**UMATILLA PLANNING COMMISSION MEETING
AGENDA
COUNCIL CHAMBERS
MARCH 23, 2021
6:30 PM**

**CITY OF UMATILLA PLANNING COMMISSION
 REPORT AND RECCOMENDATION
 FOR
 CONDITIONAL USE (CU-2-21) & SITE PLAN REVIEW (SP-2-21)**

**CITY OF UMATILLA PLANNING COMMISSION
REPORT AND RECCOMENDATION
FOR
CONDITIONAL USE CU-3-21**

**CITY OF UMATILLA PLANNING COMMISSION
REPORT AND RECOMMENDATION
FOR
SITE PLAN REVIEW SP-3-21 AND CONDITIONAL USE CU-4-21**

Exhibit B

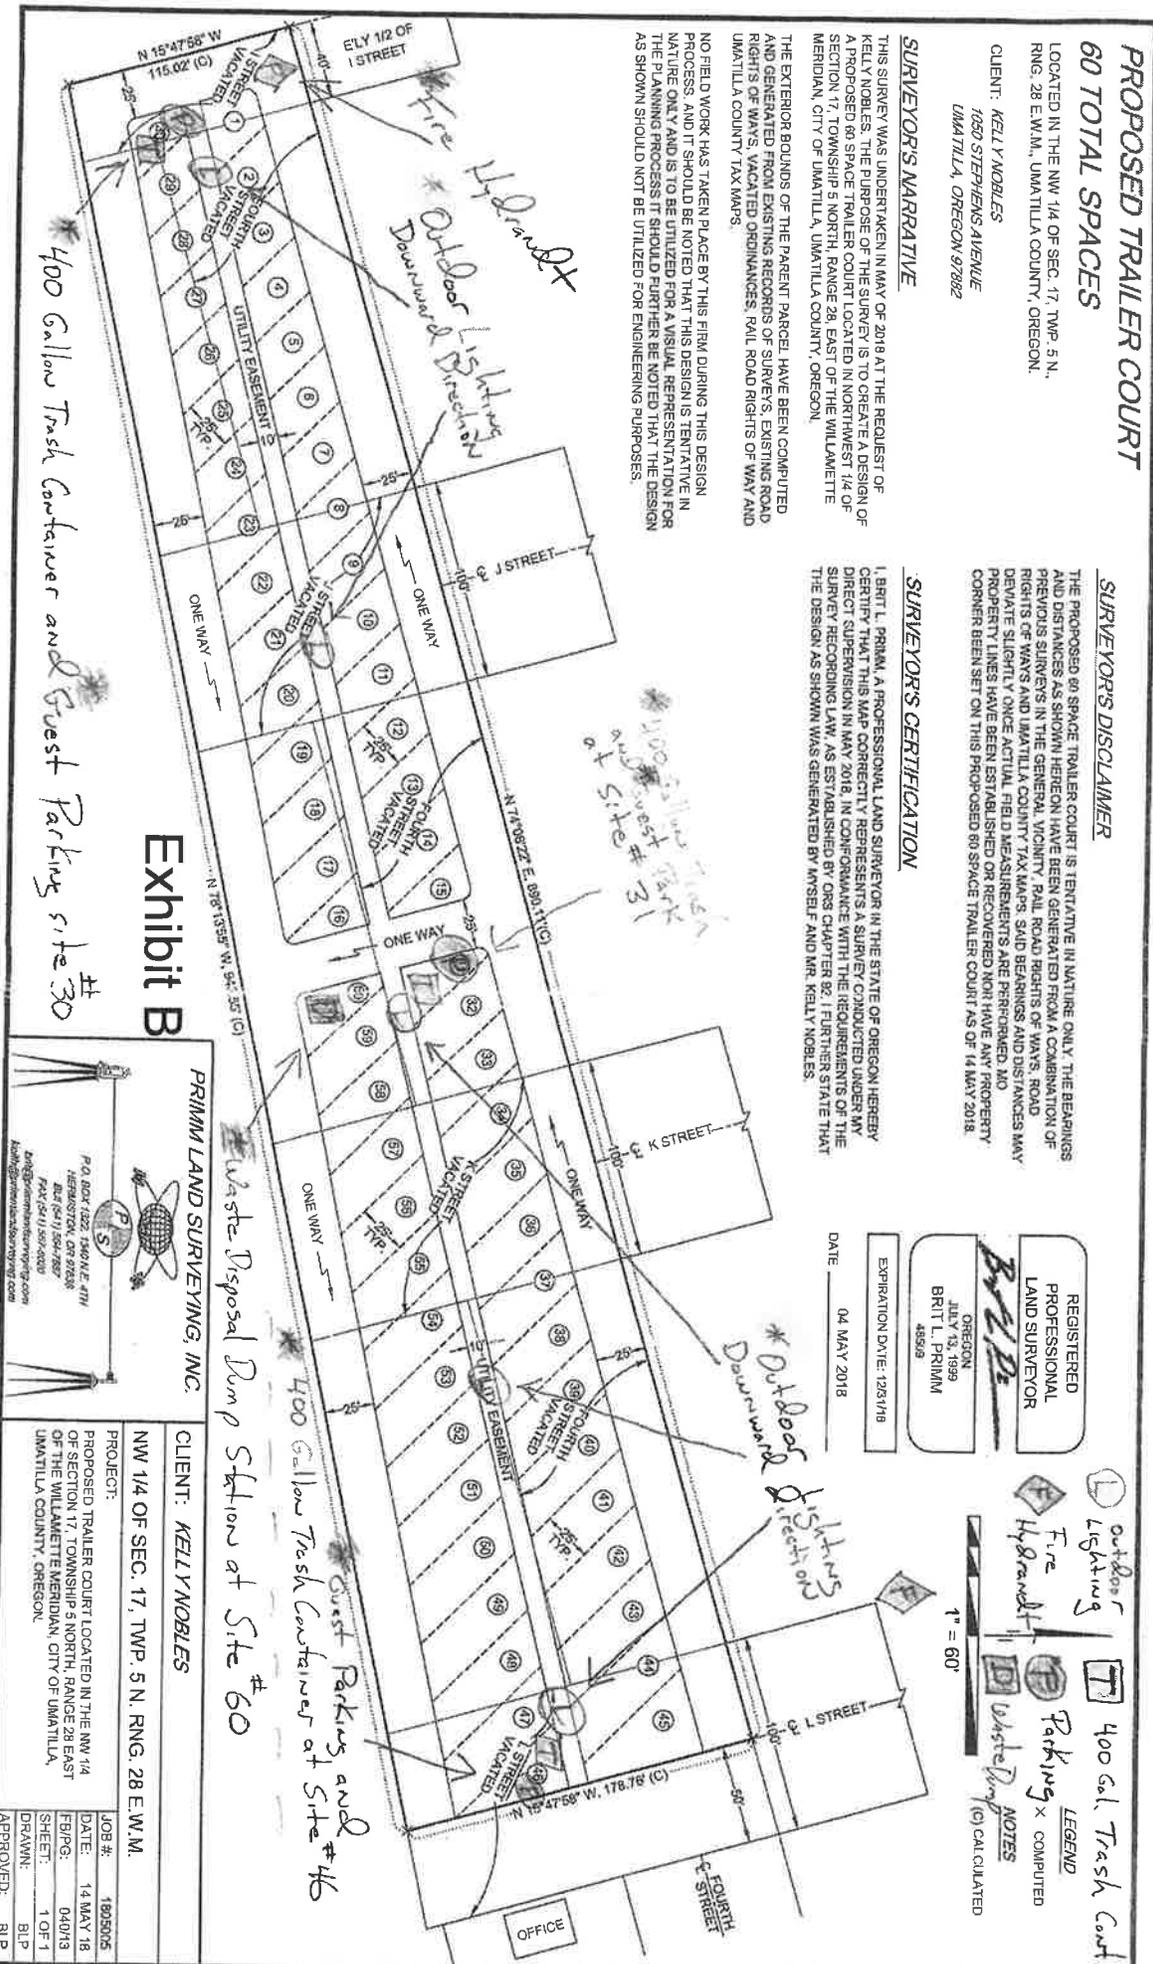
Findings: The applicant submitted site show does not list the area of the proposed RV spaces, however, a majority of the proposed spaces are a minimum of 25 feet by 30 feet, 750 square feet, starting at the western most RV spaces and increase in size as you move east. The proposed corner spaces are believed to be smaller than the required 700 square feet and the applicant is proposing to convert all of the spaces less than the required 700 square feet to additional parking and garbage collection areas. The applicant will be required to provide square footage of all proposed RV spaces on the required site plan review application and all spaces will be required to be a minimum of 700 square feet.

Conclusion: The applicant submitted site plan does not directly address the size of each proposed RV space. The site plan review application will be required to provide verification that all proposed RV spaces are a minimum of 700 square feet on the required site plan application.

Findings: The applicants submitted site plan does not show parking within the proposed RV spaces, however, the spaces would be a minimum of 25 feet by 30 feet and have space available to accommodate the required off-street. A condition of approval requiring that all RV spaces be provided with a minimum 10 foot by 20-foot parking space improved to a paved surface will satisfy this requirement.

Conclusion: The submitted site plan does not address parking spaces within each individual RV space. Therefore, staff recommends that condition of approval be imposed requiring a minimum 10 foot by 20-foot paved parking space be provided for each proposed RV space. The parking spaces must be show on the required site plan application.

Findings: The applicant's submitted site plan does not show the proposed screening. The purpose of this standard is to create a visual buffer and mitigate the negative visual impact a RV park could create. The applicant could use a combination of trees and bushes that are generally 6 feet, but screening will be required and expected to be shown on the site plan at the time of Site Plan Review.

Findings: The applicant has indicated that trash receptacles will be provided at a rate of 30 gallons for each two RV spaces. The applicants site plan shows three (3) 400-gallon trash containers, resulting in 1,200 gallons of capacity, enough to accommodate 80 RV spaces.

4. The applicant shall submit a site plan design application and construction drawing to the City for review prior to starting any construction activity. The site plan and construction drawing shall include connections to City sewer and water (at least 75% of the RV spaces shall be provided water and sewer), full city standard improvement of the access to the park as well as within the park, sanitary sewer and water systems within the park, electrical services (All RV spaces shall be provided electrical service), one waste disposal dump station for RVs, location of outdoor lighting, landscaping, fire hydrants, area of proposed RV spaces (all RV spaces shall be a minimum 700 square feet), off-street parking (each RV space shall have at least one 10' x 20' paved parking space) and sight-obscuring screening.
